TEXAS COMMISSION ON ENVIRONMENTAL QUALITY

Re: Approval to Conduct On-Site Wastewater Treatment and Irrigation
Falcon Refinery
1472 FM 2725, San Patricio County, Ingleside, Texas 78362
SUP111

Texas Commission on Environmental Quality
INTEROFFICE MEMORANDUM

Subject: National Oil Recovery Corporation (NORCO), Falcon Refinery Superfund Site (the facility)

WATER TREATMENT AND IRRIGATION SYSTEM

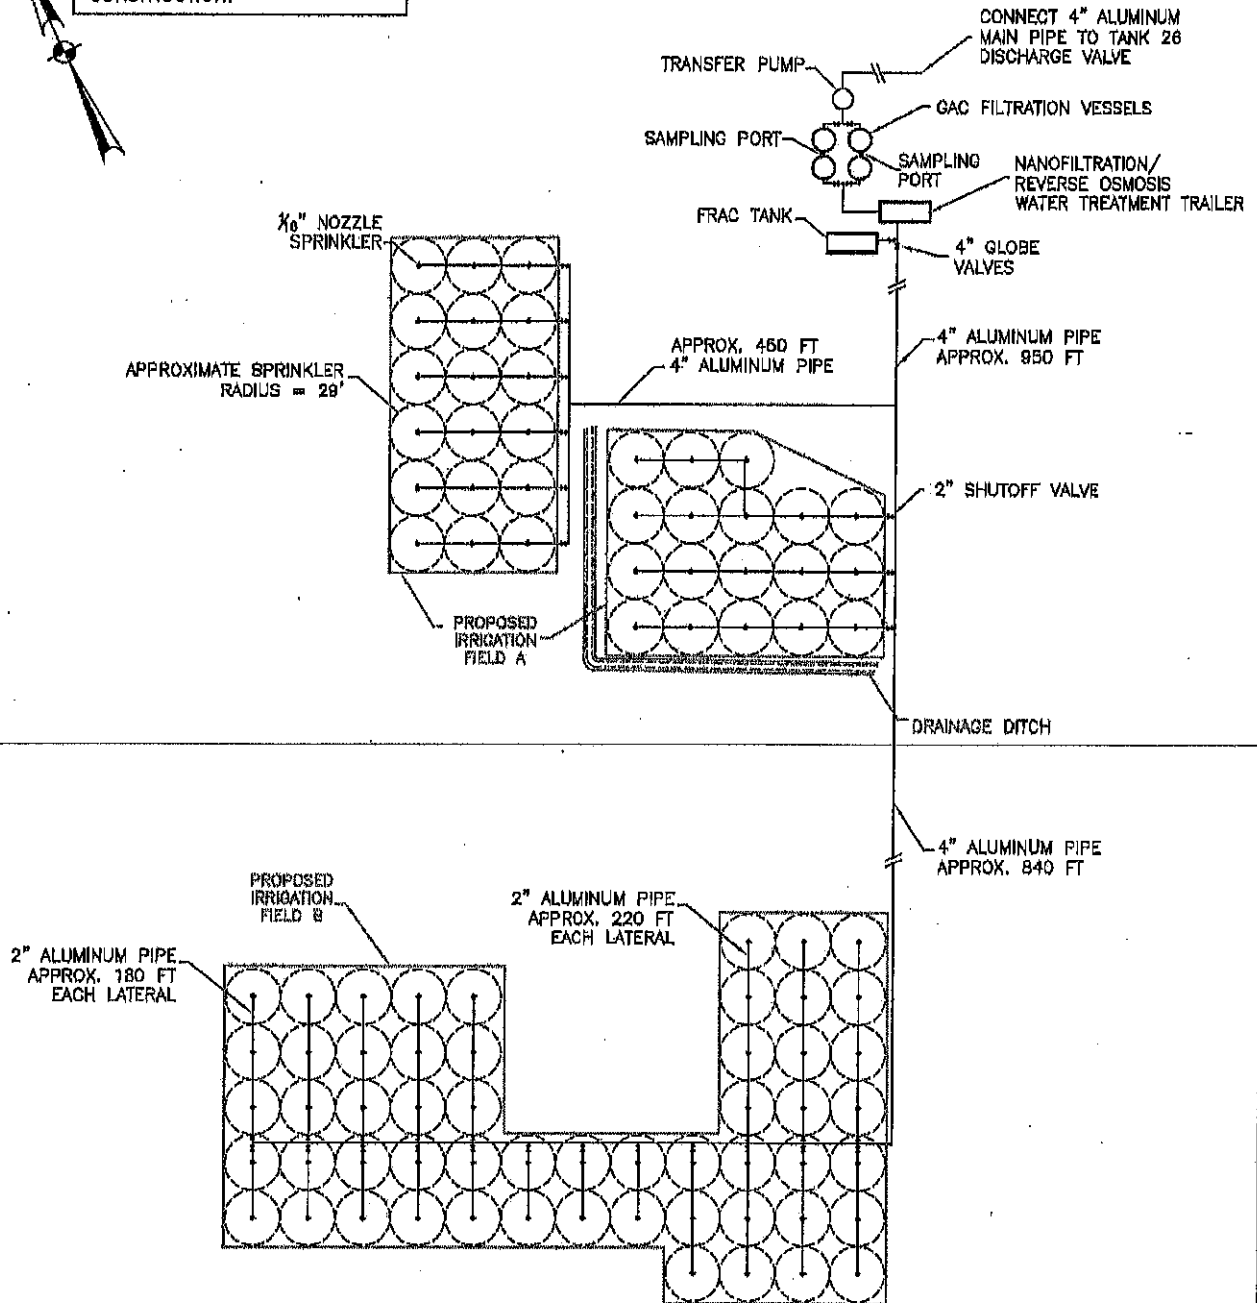
7. The irrigation system shall be constructed in accordance with the conceptual design provided in Attachment C.
 8. The quality and the loadings of the treated wastewater shall be maintained as follows:
 - a. hydraulic loading: ≤ 3.18 inches per acre per month (in/ac/month)
 - b. daily maximum effluent flow: $\leq 15,649$ gallons per day (0.015649 MGD)
 - c. daily maximum total nitrogen loading: ≤ 0.436 lbs/acre/day
 - d. conductivity: < 4.0 milli-Siemens per centimeter (mS/cm)
 - e. pH: between 6.0 and 9.0 standard units.
-
